United States Patent and Trademark Office

APPLICATION NO.	FILING DATE	FIRST NAMED INVENTOR	ATTORNEY DOCKET NO.	CONFIRMATION NO.	
10/623,236	07/21/2003	George Arrotta	2200/5/02	2877	
7590 02/01/2005			EXAM	EXAMINER	
William L. Muckelroy, Esq., P.C.			CHIN, P	CHIN, PAUL T	
Ewing Professional Park Suite 3A			ART UNIT	PAPER NUMBER	
1901 N. Olden Avenue			3652		
Trenton, NJ 0	8618		DATE MAILED: 02/01/2005	5

DETAILED ACTION

10/623,236 Exhibit A 5,615,920 Sheet 3 of 3

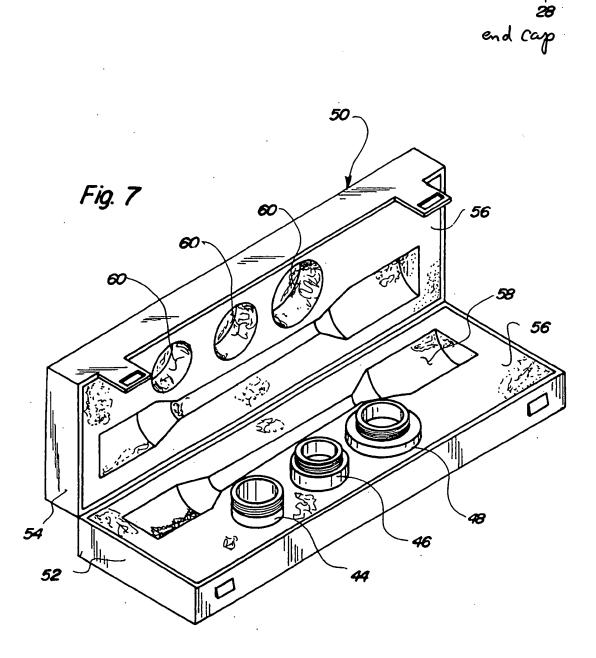
- 7. Claims 1,13, and 17, as best understood, are rejected under 35 U.S.C. 103(a) as being unpatentable over O'Kane et al. (5,615,920) (see PTO-892) in view of Twachtman (2,993,723). O'Kane et al. (5,615,920) discloses a telescoping retrieving device comprising an end cap (28), an end section (see Exhibit A) being connected to the end cap, a tubular section (34,34) slidably to receive the end section, an electrical conducting insert (20) (Fig. 1) disposed through the tubular section and the end section, the insert being connected to a power supply (18) and a switch module (Fig. 1). O'Kane et al. (5,615,920) does not clearly show that the end section and the tubular section are made of a non-magnetizable material. However, Twachtman (2,993,723) discloses a magnet and a cylinder casing (14) of a non-magnetic material, enclosing the magnet (Col 2, lines 25-29). Accordingly, it would have been obvious design choice to provide a non-magnetic material on the tubular section (34) of O'Kane et al. (5,615,920) as taught by Twachtman (2,993,723) so that the modified O'Kane et al. (5,615,920) would not attract the metal object by the tubular sections.
